AMERICAN POWER CONVERSION

DESCRIPTION	SHEET
SB208 CIRCUIT BOARD SCHEMATIC	A
PRODUCT: 250/400/600 INT'L BACK-UPS	APCC PART #: 0S-208

DATE	BY	SCALE	DWG	REV
3/22/91	ESM		E208-10	10

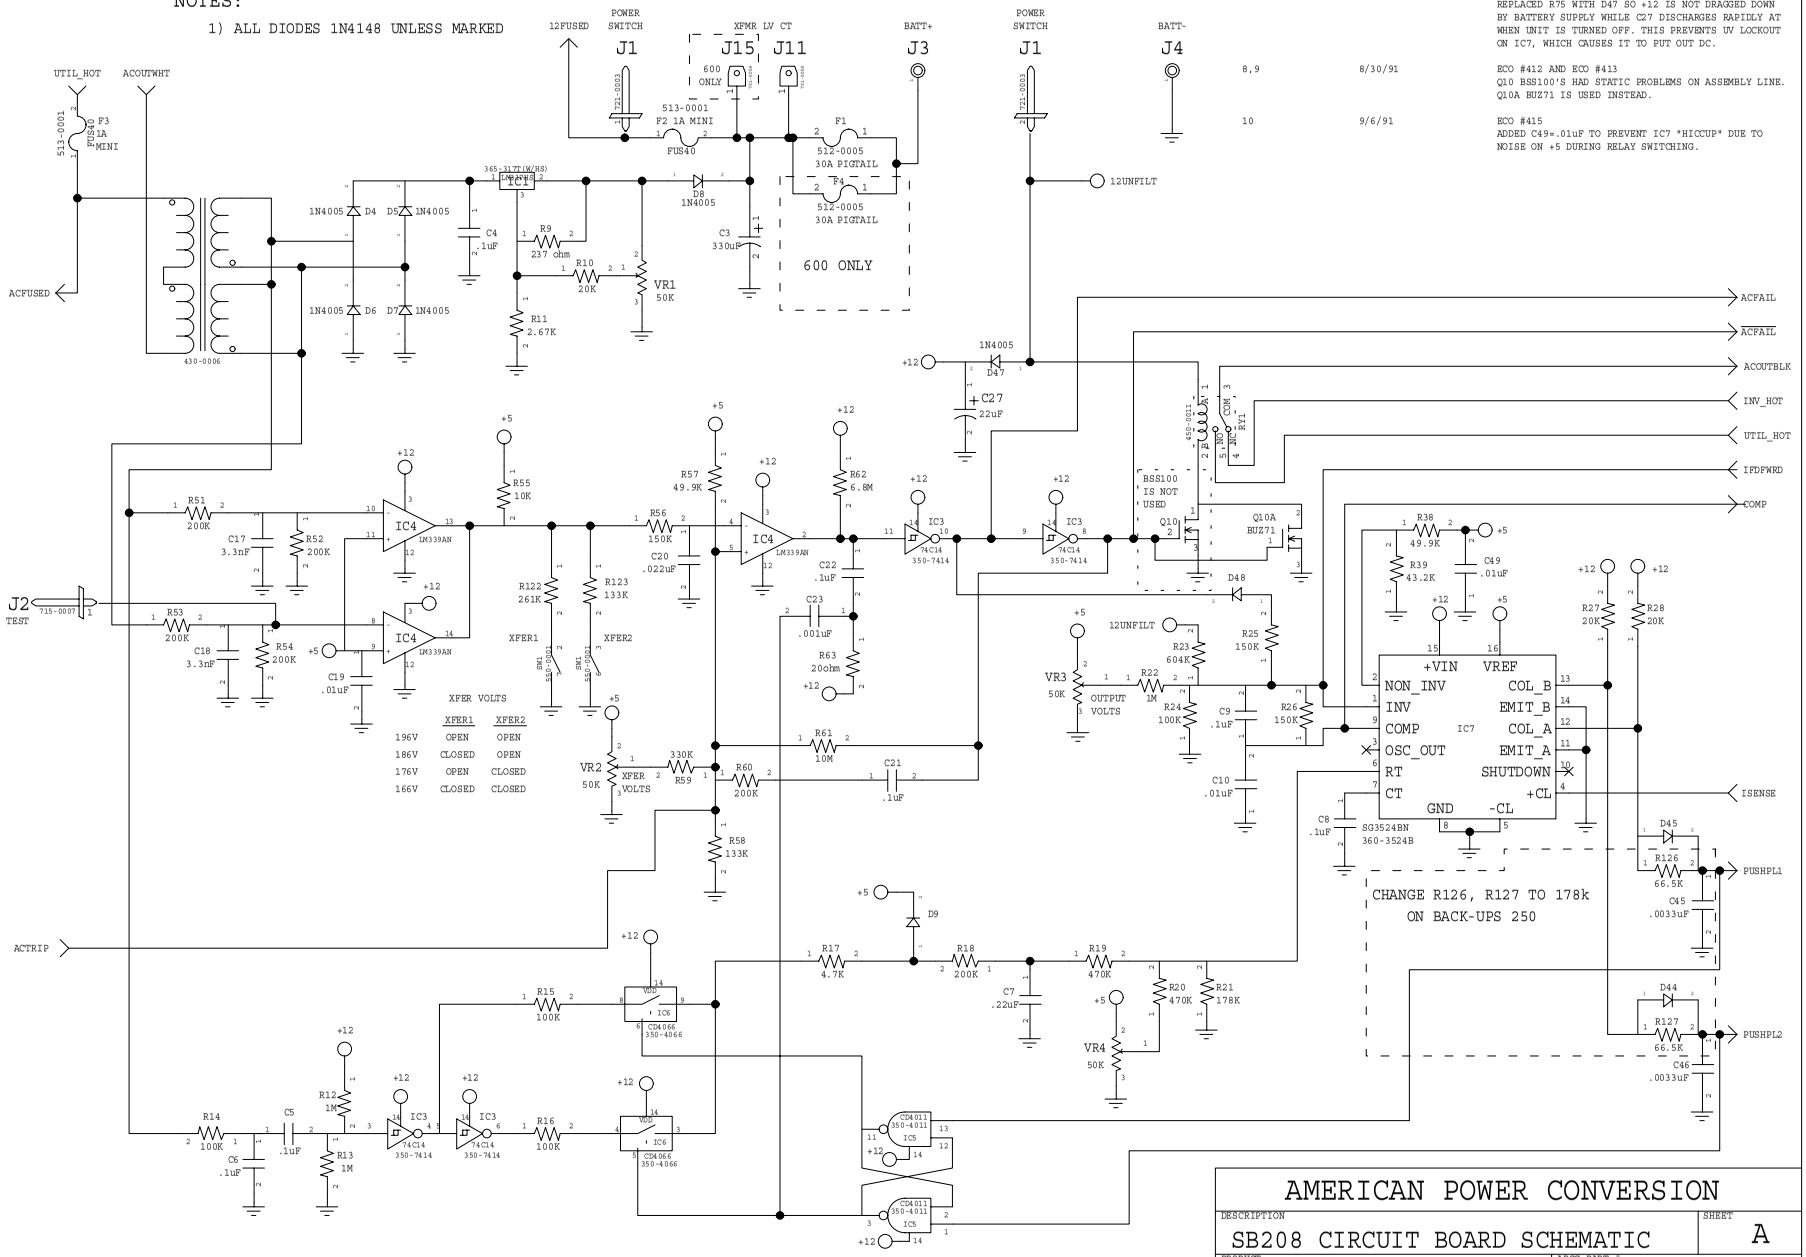
REV #	DATE	REVISION
7	7/17/91	ECO #391 AND ECO #394 REPLACED R75 WITH D47 SO +12 IS NOT DRAGGED DOWN BY BATTERY SUPPLY WHILE C27 DISCHARGES RAPIDLY AT WHEN UNIT IS TURNED OFF. THIS PREVENTS UV LOCKOUT ON IC7, WHICH CAUSES IT TO PUT OUT DC.
8,9	8/30/91	ECO #412 AND ECO #413 Q10 BSS100'S HAD STATIC PROBLEMS ON ASSEMBLY LINE. Q10A BUZ71 IS USED INSTEAD.
10	9/6/91	ECO #415 ADDED C49=.01uF TO PREVENT IC7 "HICCUP" DUE TO NOISE ON +5 DURING RELAY SWITCHING.

DESCRIPTION	SHEET
SB208 CIRCUIT BOARD SCHEMATIC	B

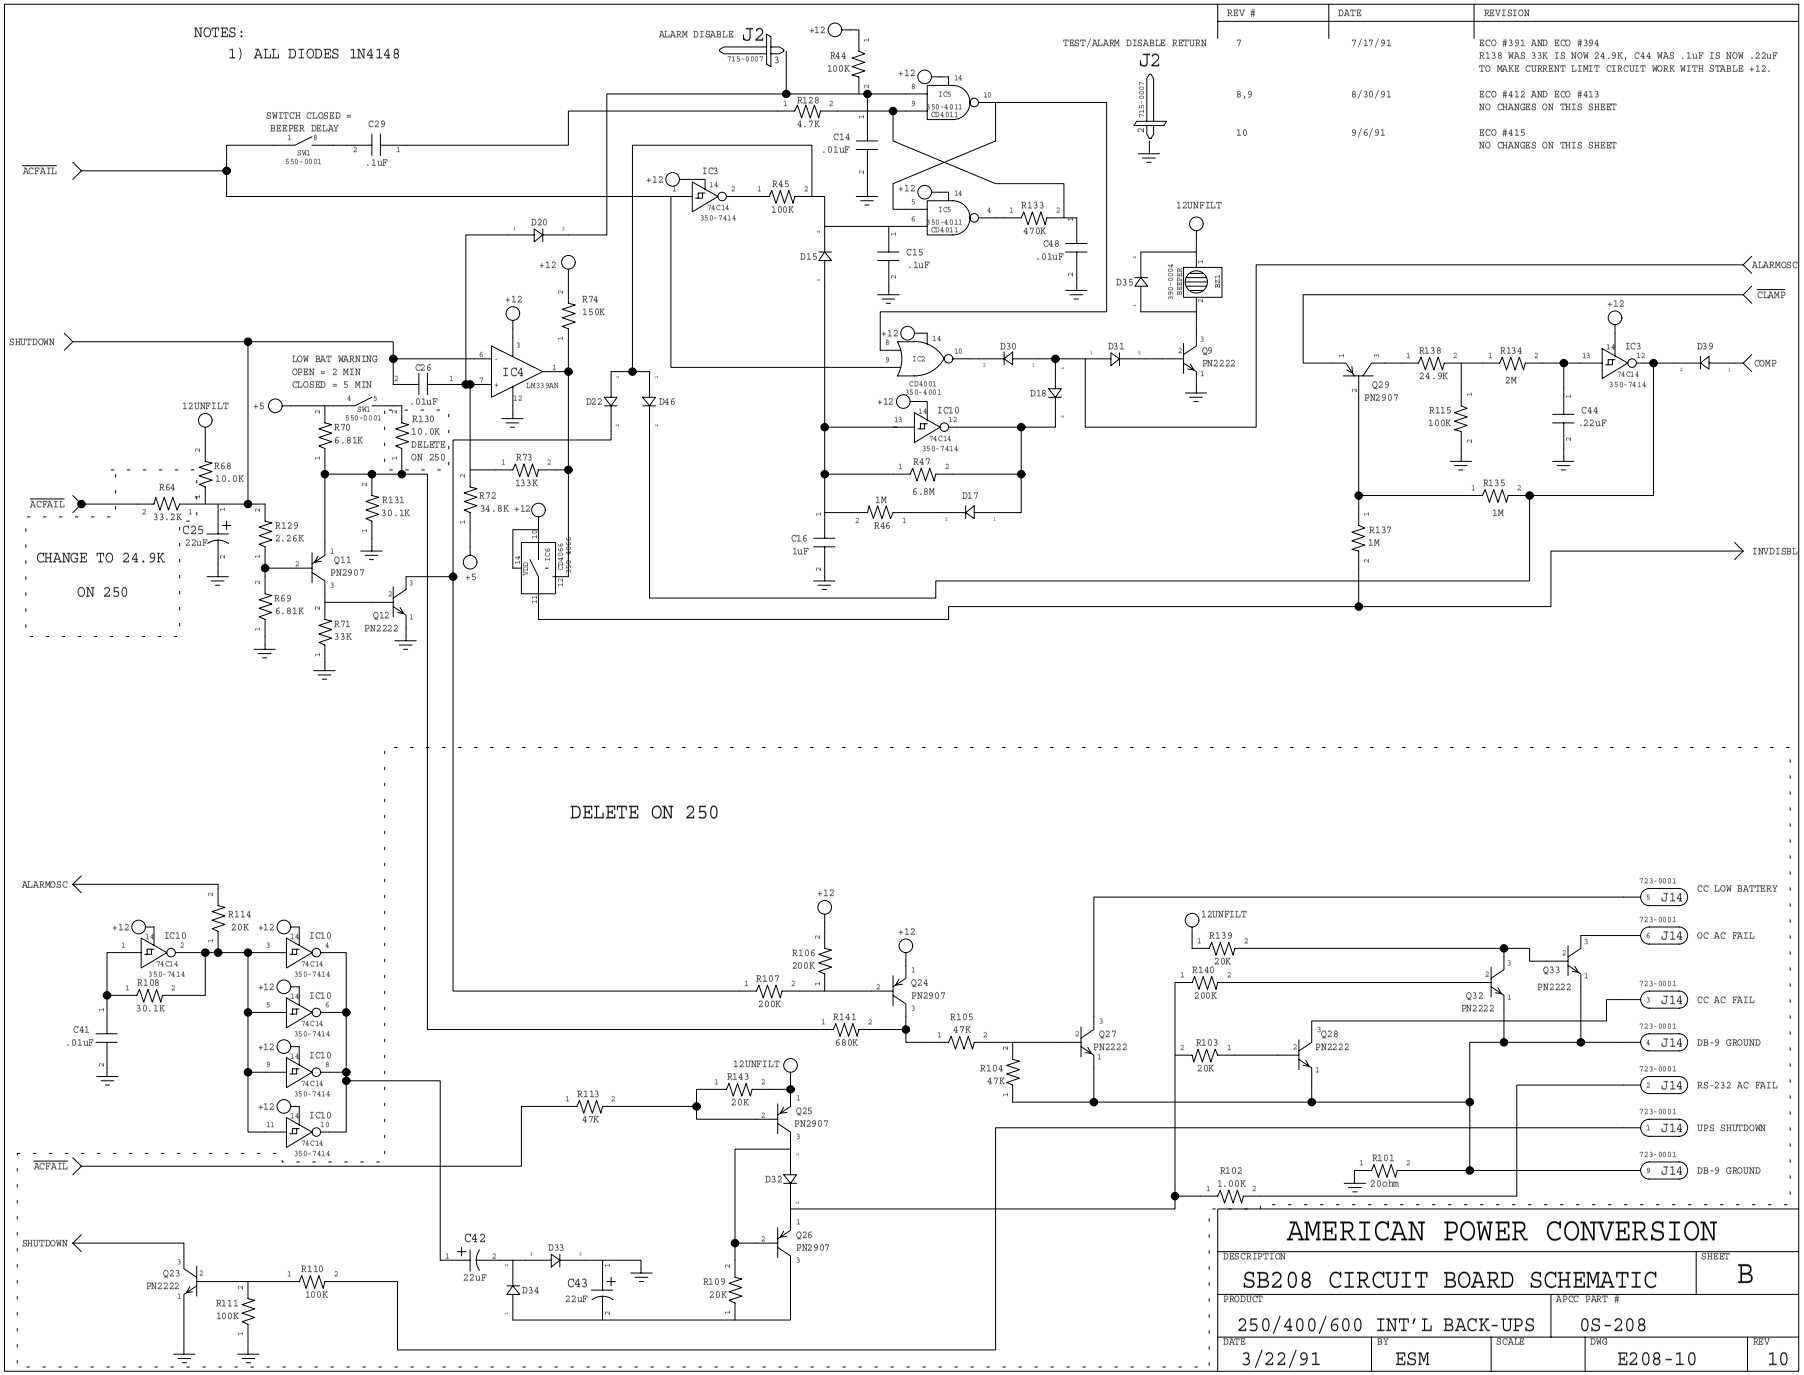
REV #	DATE	REVISION
7	7/17/91	ECO #391 AND ECO #394 R138 WAS 33K IS NOW 24.9K, C44 WAS .1uF IS NOW .22uF TO MAKE CURRENT LIMIT CIRCUIT WORK WITH STABLE +12.
8,9	8/30/91	ECO #412 AND ECO #413 NO CHANGES ON THIS SHEET
10	9/6/91	ECO #415 NO CHANGES ON THIS SHEET
